120 High Point a

Re. Percolation Test

Application for Disposal Works Construction Permit

PLAN SHOWING SEWAGE DISPOSAL

PLAN SHOWING SEWAGE DISPOSAL

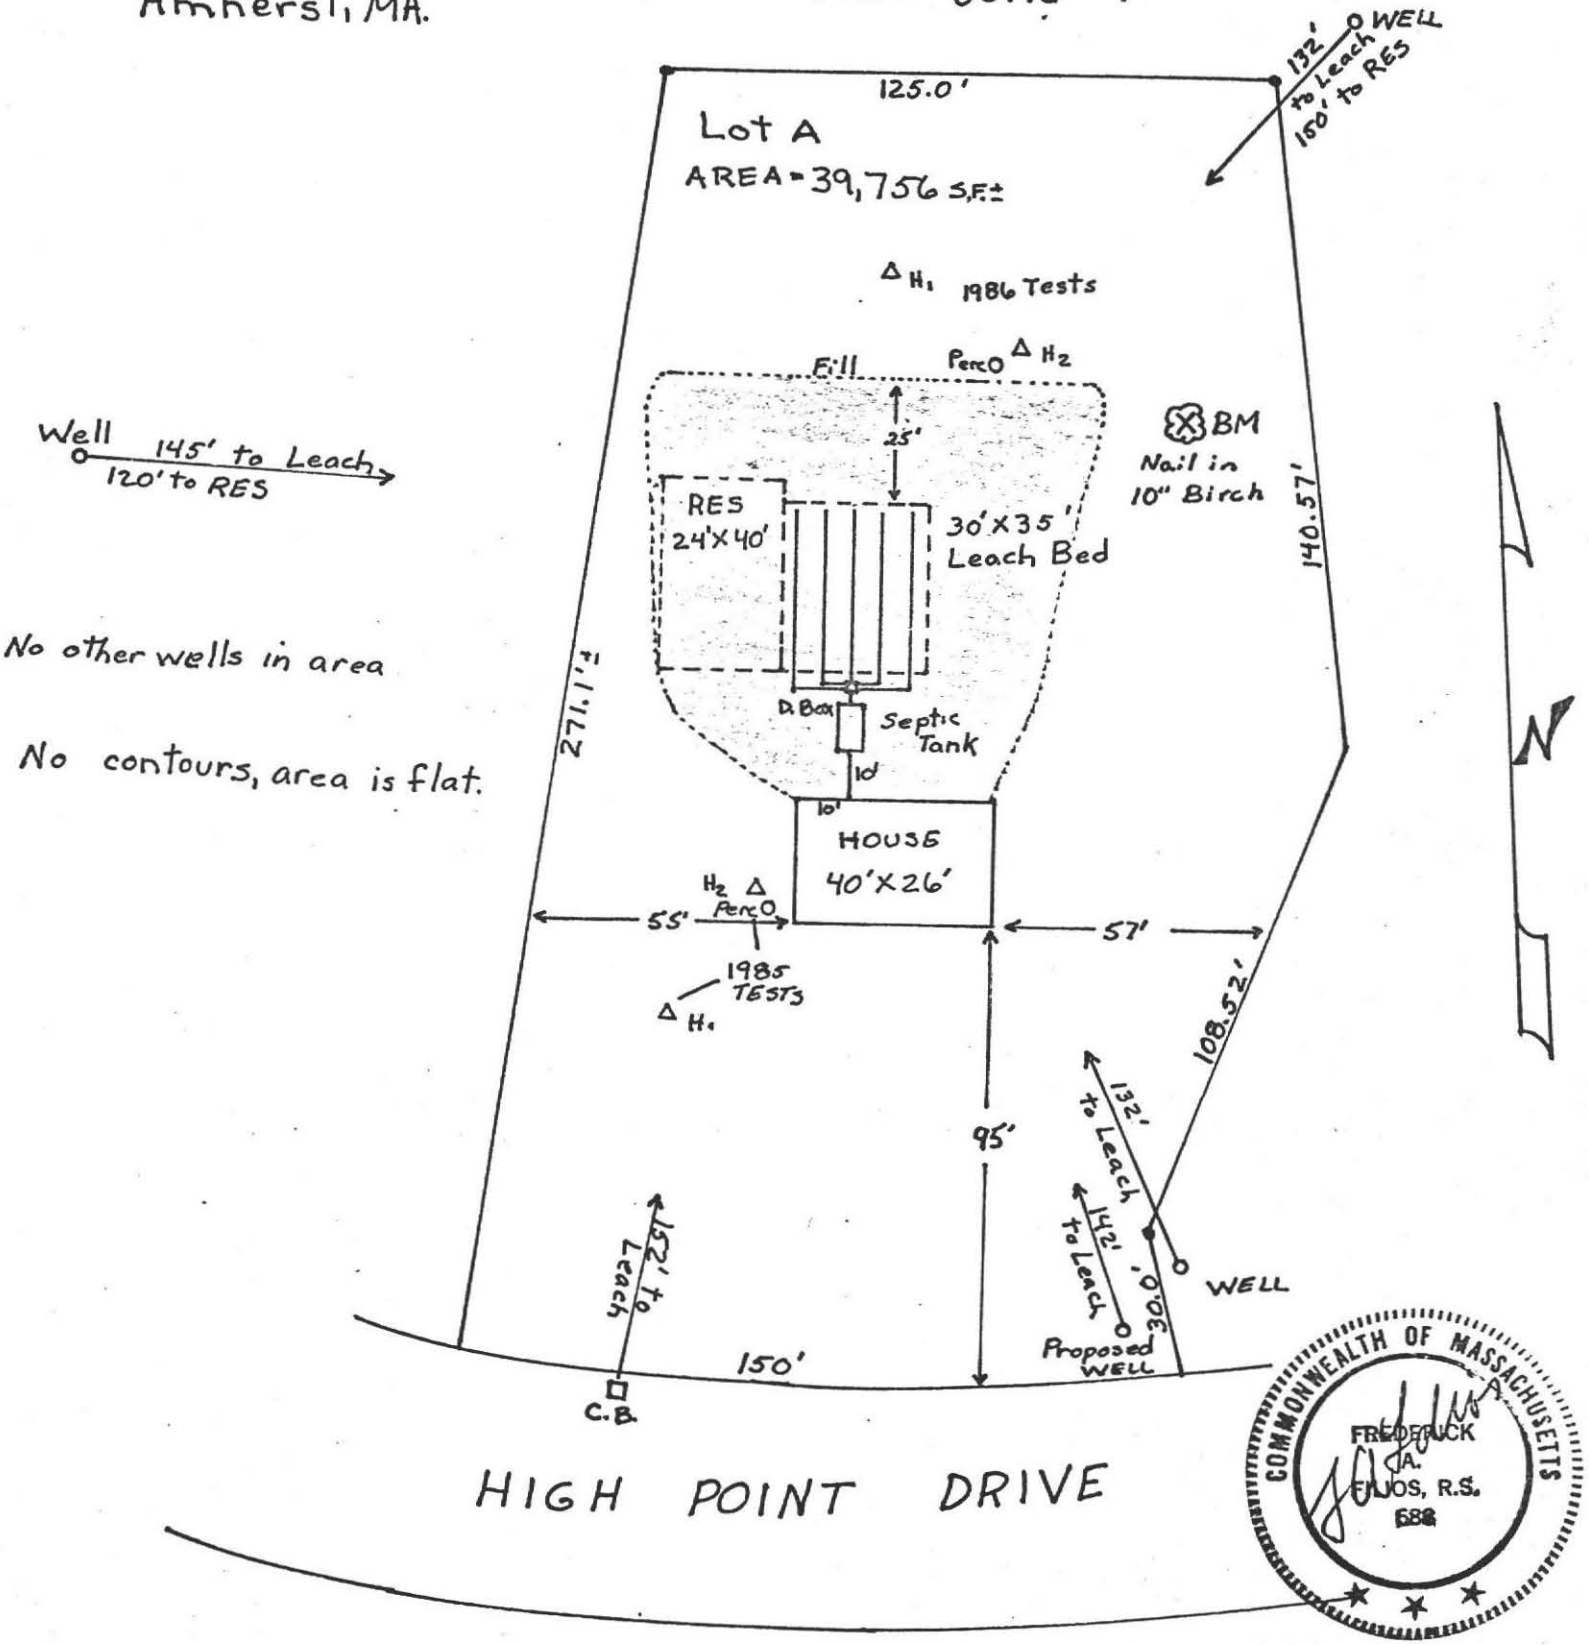
This will serve as notice that your permit for a private sewage disposal system on Lot A, so called, located on High Point Drive in Amherst, dated May 14, 1986, is hereby revoked.

The reason for the revocation is that the provisions contained in Amherst Board of Health Regulations adopted on October 3, 1973, (copy enclosed) are not met. The specific violation is that the required 150 ft. lateral distance between any water supply and private sewage disposal system has not been met. The revised plan dated June 12, 1986, contains information not included in the original permit application which further violates these provisions.

PLAN SHOWING SEWAGE DISPOSAL

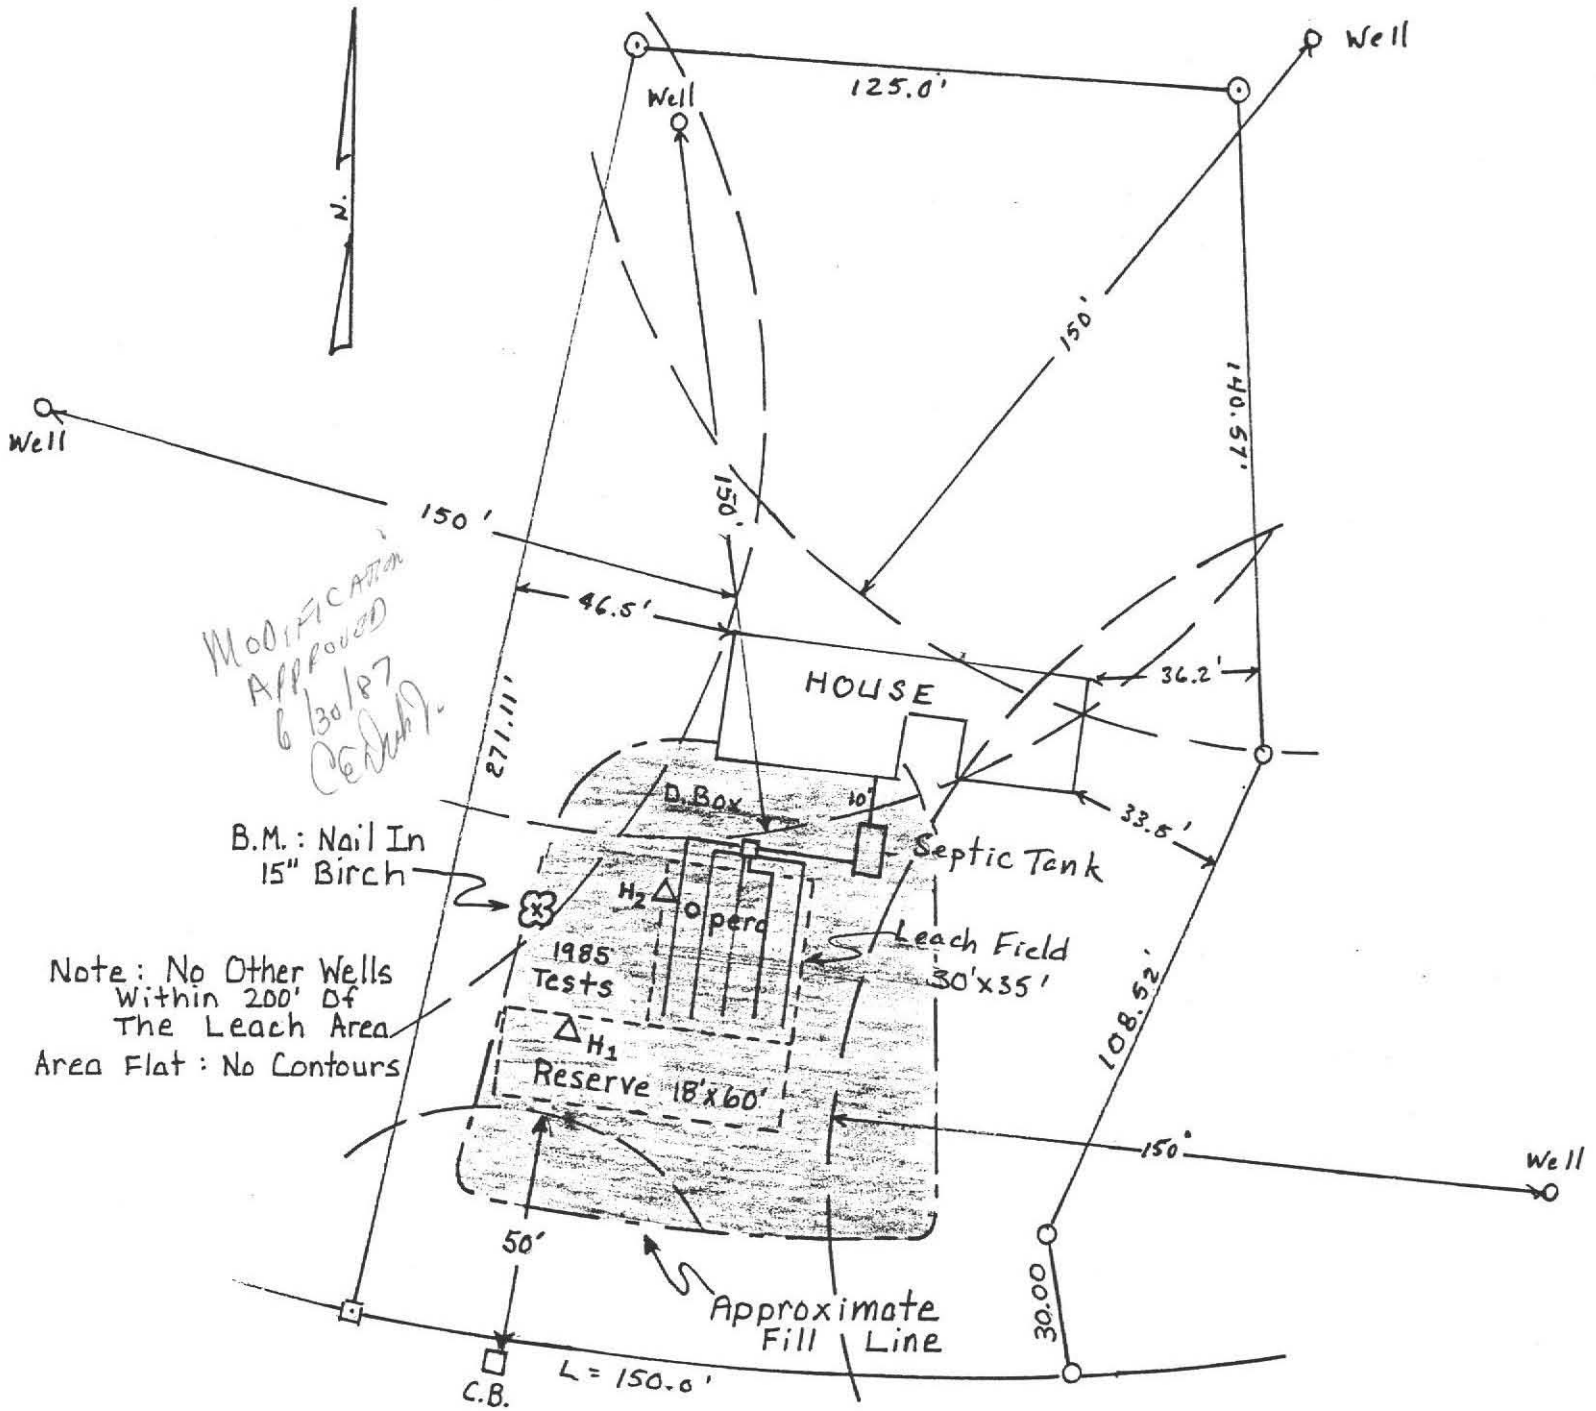
Recent observations of the location of the water supply and building foundation on your Lot"A: - 120 High Point Drive in Amherst indicates that their locations are not as shown on the approved plan which is part of the Private Sewage Disposal permit issued in January of 1987.

It appears that the house location has been moved forward (towards road) and the water supply has been moved to the North-Westerly corner of the lot. It is also apparent that the location of the septic tank will have to be moved and can be located outside the 150' distance required from water supply to sewage disposal system.

Please have the revised plan prepared and submitted to the Health Dept. for review at your earliest convenience.

MODIFICATION APPROVED 6/30/87

PLAN SHOWING SEWAGE DISPOSAL

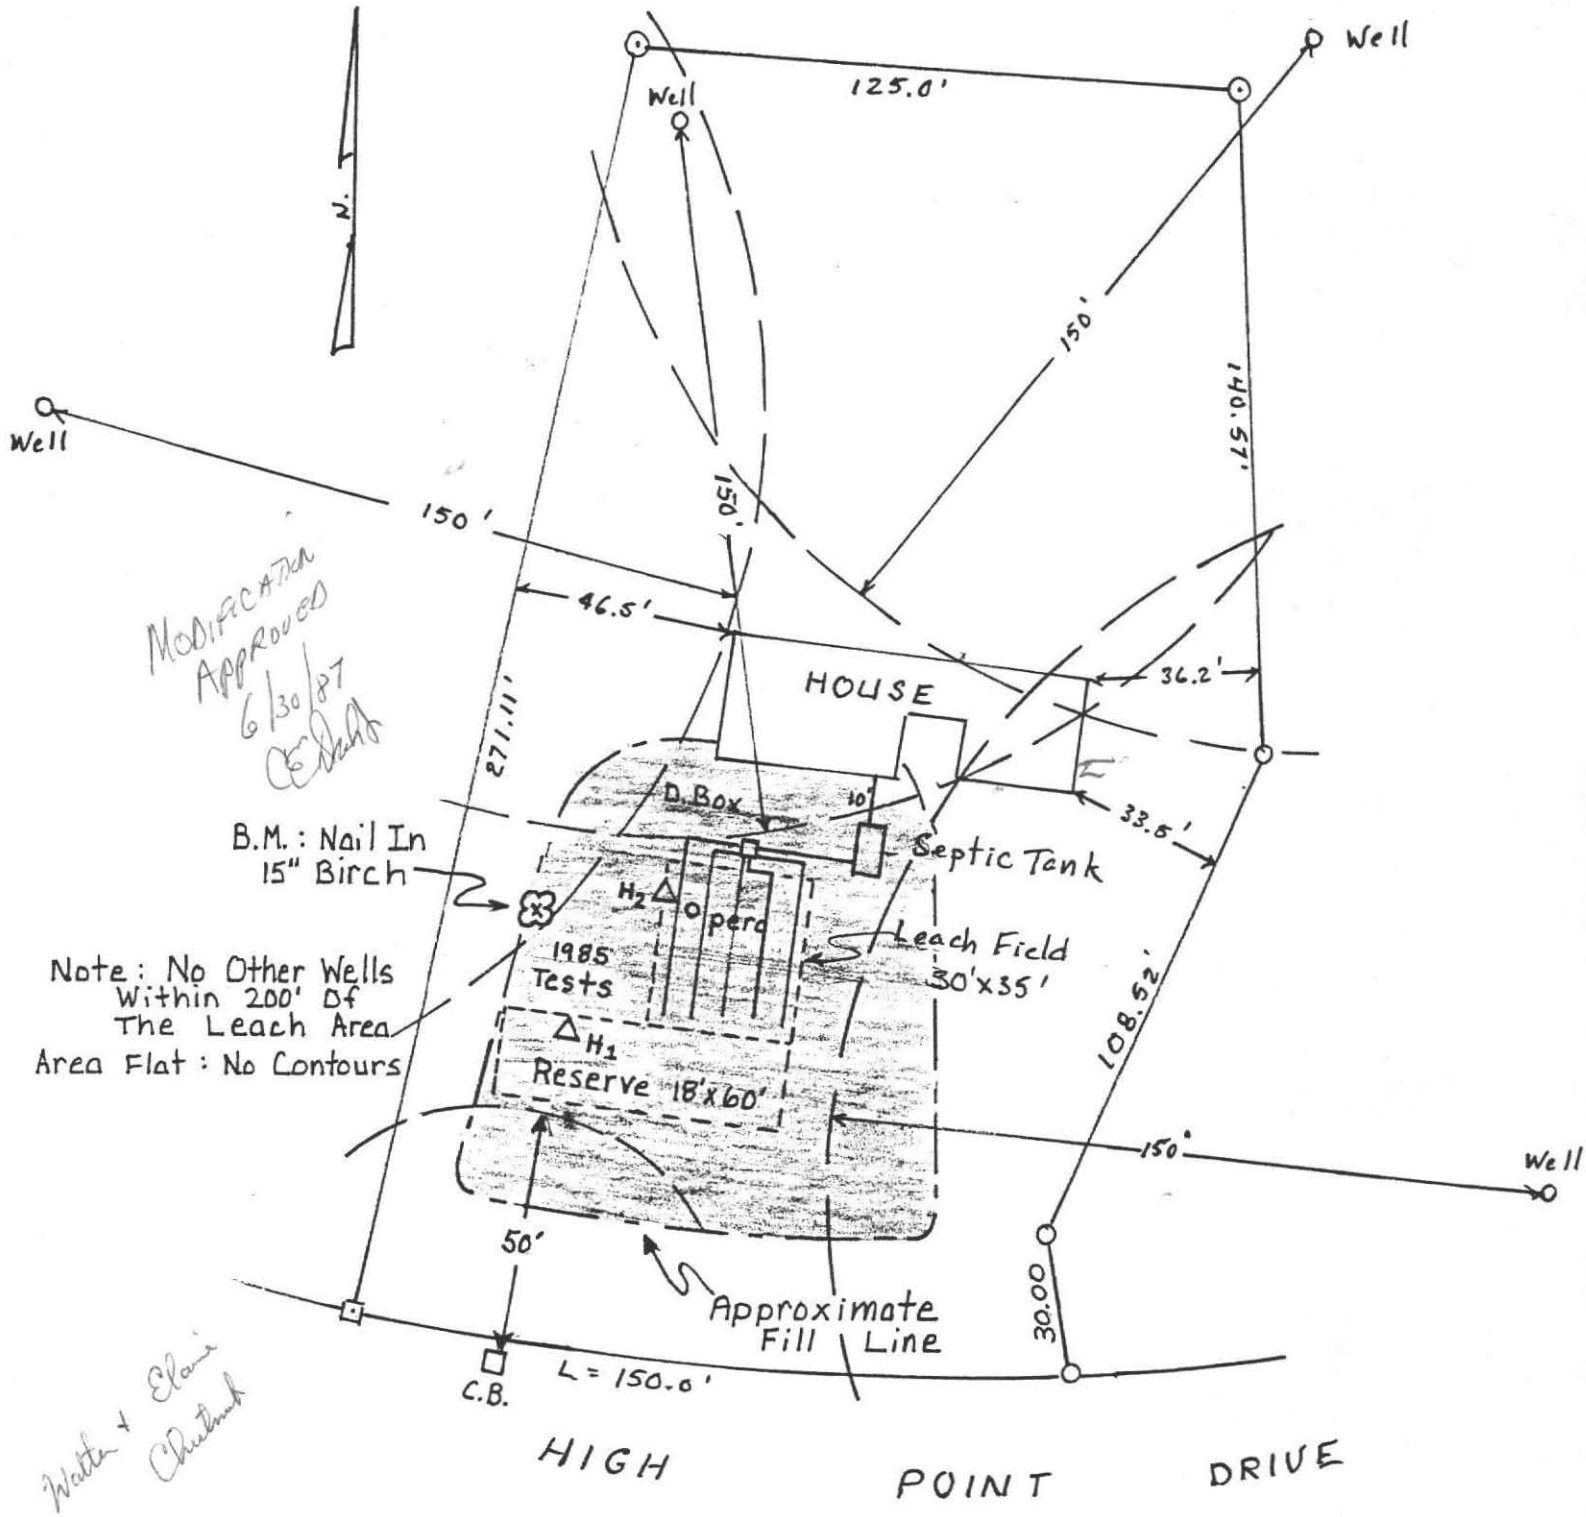
WE RESIDE AT 65 OVERLOOK DRIVE. OUR PROPERTY ABUTS 120 HIGHPOINT DRIVE, LOT A. THE ATTACHMENTS TO THE DISPOSAL WORKS CONSTRUCTION PERMIT, 86-30 REVISED, INDICATE THE WELL AND PRIVATE SEWAGE DISPOSAL SYSTEM FOR LOT A WILL BE LOCATED WITHIN 150 FEET OF EACH OTHER.

A) IF THE PRIVATE SEWAGE DISPOSAL SYSTEM AND WELL FOR LOT A, 120 HIGHPOINT DRIVE, WILL BE IN COMPLIANCE WITH BOARD OF HEALTH REGULATIONS;

B) IF THE DISPOSAL WORKS CONSTRUCTION PERMIT, 86-30 REVISED, HAS BEEN PROPERLY ISSUED;

C) IF THE DISPOSAL WORKS CONSTRUCTION PERMIT, 86-30 REVISED, SHOULD BE REVOKED.
